**Attachment #5**

Staff reports for DSP amendment (DSP#2017-0022) and original request (DSP#2016-0025)

**Development Site Plan #2017-0022**  
**Subdivision #2017-0006**  
**Street Name Case #2017-0001**  
**3832-3834 Seminary Road – Karig Estates**

**Graphic #2-B: Proposed New Lot #4 Layout**

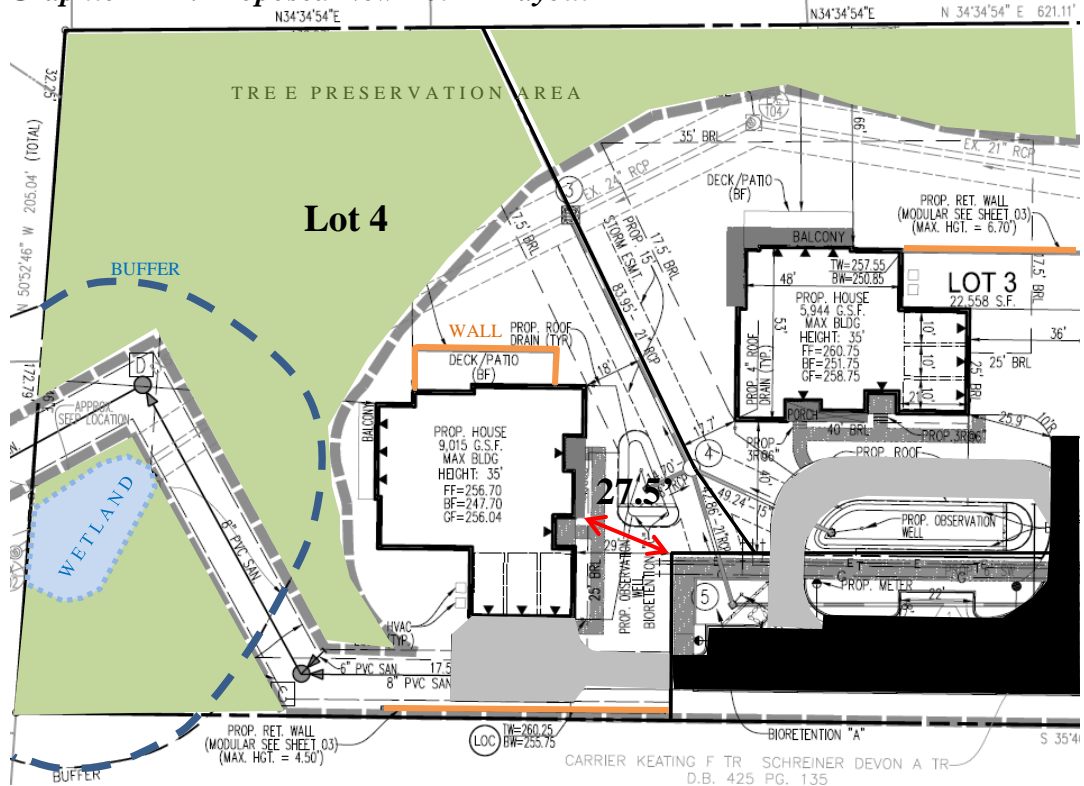
1. The orientation of the dwelling would be flipped such that the entrance to the attached garage would be located on the east side of the dwelling instead of the previously-approved west side of the dwelling;

2. As a consequence of relocating the garage entrance on Lot #4, the previously-approved winding driveway that traverses the front yard, as well as the associated turn-around area, would be eliminated in favor of a shorter, straight driveway from the end of the proposed new street and a smaller turn-around area; and

3. The newly-oriented dwelling would be shifted to the north, closer to the end of the new public street, by approximately 12.5 feet, resulting in a front yard setback of 27.5 feet, which would need to be modified from the 40-foot setback requirement.

4. The previously-approved 13-foot retaining wall would now become much shorter in length and only measure five feet in height, and a new 4.5-foot retaining wall would be added to the east of the dwelling near the eastern property line.

Although the building footprint has not significantly changed, the relocation of the dwelling on Lot #4 has changed the front, side, and rear setbacks. In addition, the portion of the dwelling's basement that is located above average finished grade has increased. Based on the definition of floor area, the floor area ratio (FAR) for Lot #4 has therefore increased compared to the previously-approved site plan, from 0.17 to 0.25, which is the maximum allowable FAR in the R-20 zone. A comparison of the previously-approved dwelling location to the currently-proposed dwelling location on Lot #4 can be found in Graphics #2-A and #2-B on the following page.

**Graphic #3: Front Yard Modification Exhibit**

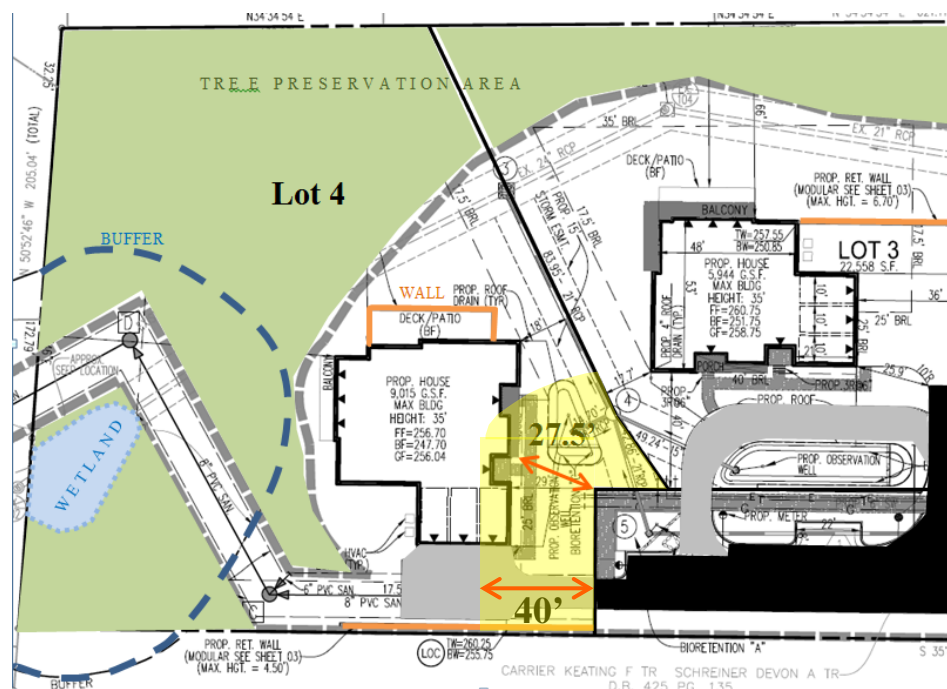
The requested modification of the front yard requirement on Lot #4 from 40 to 27.5 feet is desirable in this instance because it would limit the degree of impact from the development on the swale. Although the swale is not a regulated feature, limiting the changes to the swale to the extent reasonably necessary supports good urban planning practice and good site development.

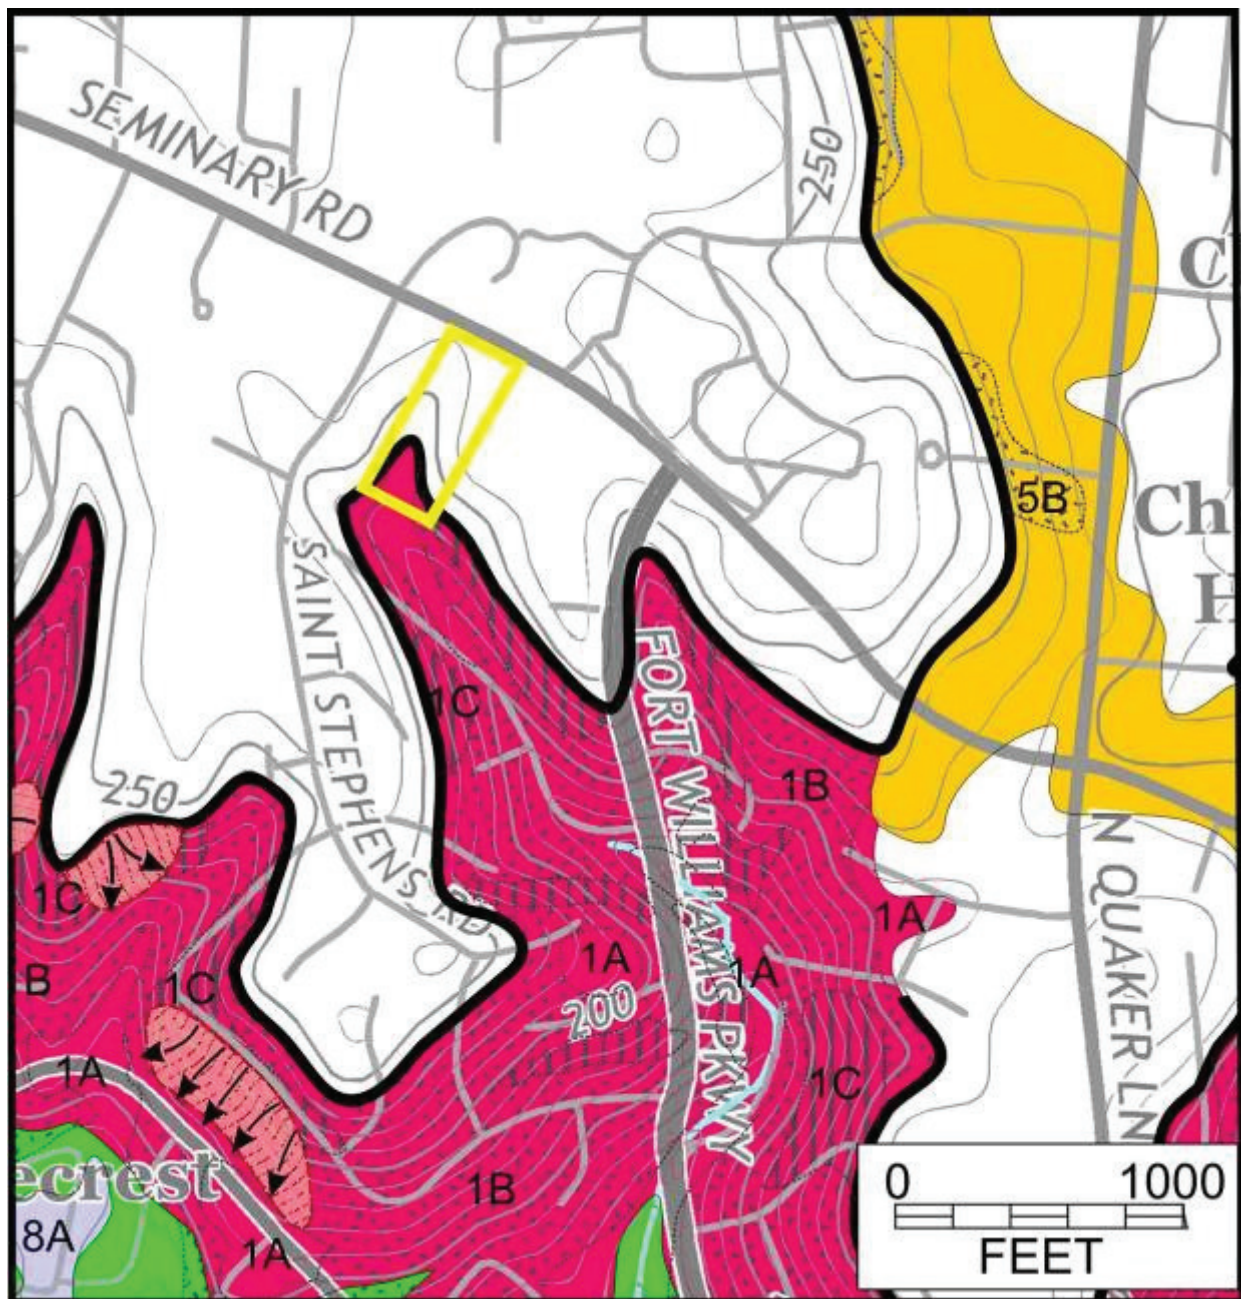
The development plan for the site contemplates extensive regrading as well as various structures and activities that are likely to significantly alter near-surface hydrology, both at the site itself and in the underlying clay that holds up the slopes below the site. These are precisely the sorts of activities that are well known to trigger slope failures. Considering that the site is situated at the crown of a major escarpment known to be landslide prone, policy makers would be well advised to think long and hard about the long-term impact of the proposed development on slope stability, particularly in light of the fact that the cost of any

subsequent slope failures will be borne not by the developer or occupants of Stuarts Walk, but by existing residences located below the site on Colonel Ellis Drive who are impacted by it.
